EPA-330/2-88-036

Hazardous Waste Ground-Water Task Force

Evaluation of U.S. Pollution Control, Inc. Grassy Mountain Facility Utah

UPDATE OF THE HAZARDOUS WASTE GROUND-WATER TASK FORCE
EVALUATION OF U.S. POLLUTION CONTROL, INC.
GRASSY MOUNTAIN FACILITY

Figure 9. General Monitoring Well Construction (MW9 through MW25)

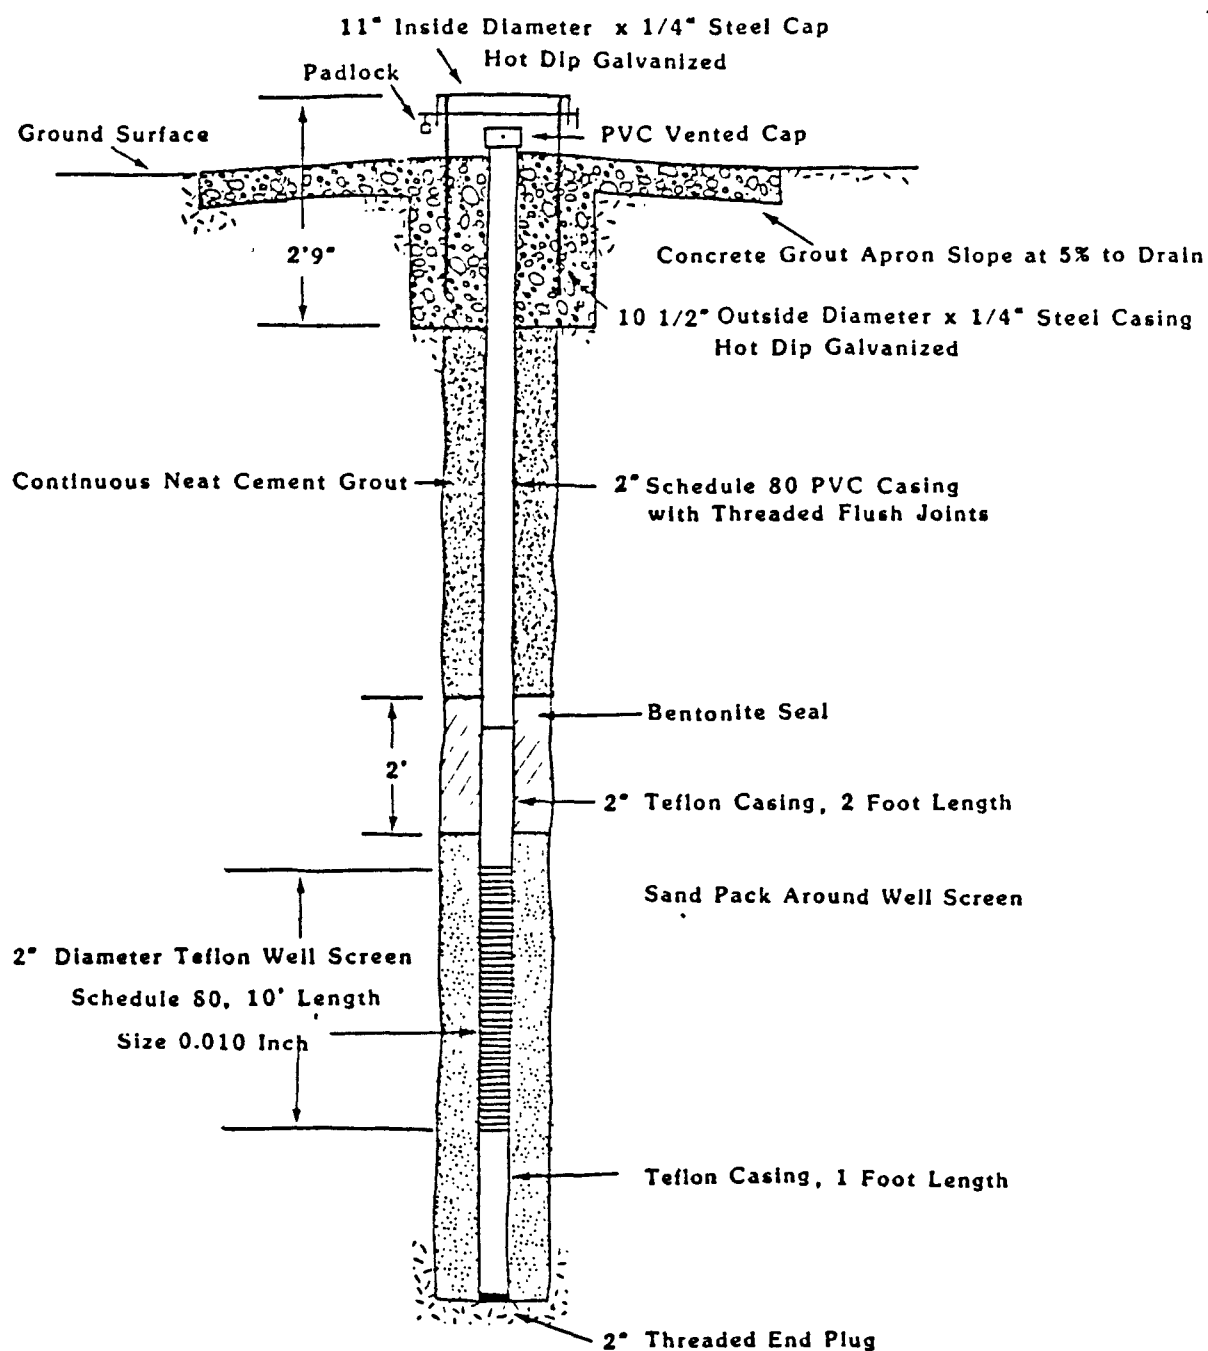
The proposed design for future monitoring well construction is acceptable. USPCI should, however, provide to the State and EPA legible well construction diagrams that completely show the design and position of each well. The diagrams provided to the Task Force were not completely legible and complicated the verification of well specifications.

FIGURE 10. WELL CAP ASSEMBLY

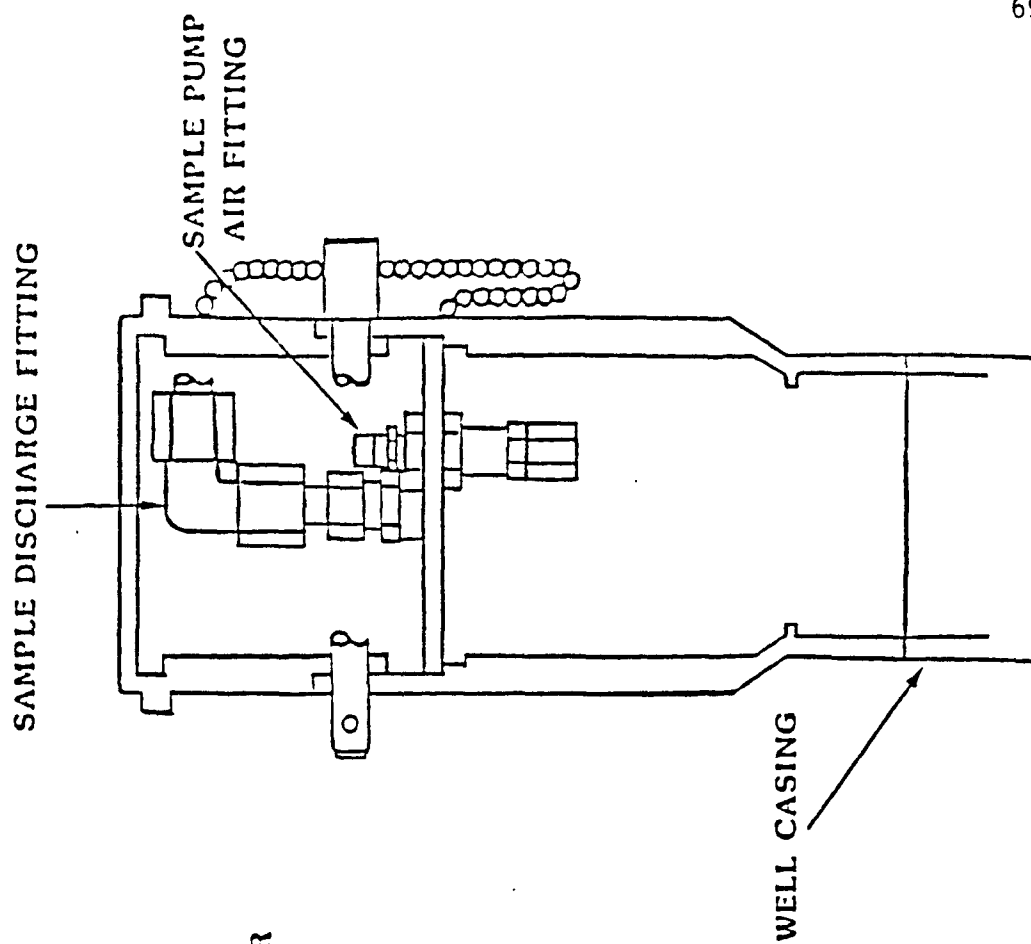
All the USPCI wells, except MW-8, had dedicated Well Wizard pumps, including a wellhead assembly from which the pumps were suspended. The wellhead assembly had an access port through which the water level sensor and cord were lowered [Figure 10]. Water levels were measured with reference to the top of the cap on the top of the well casing, which was a surveyed reference point.
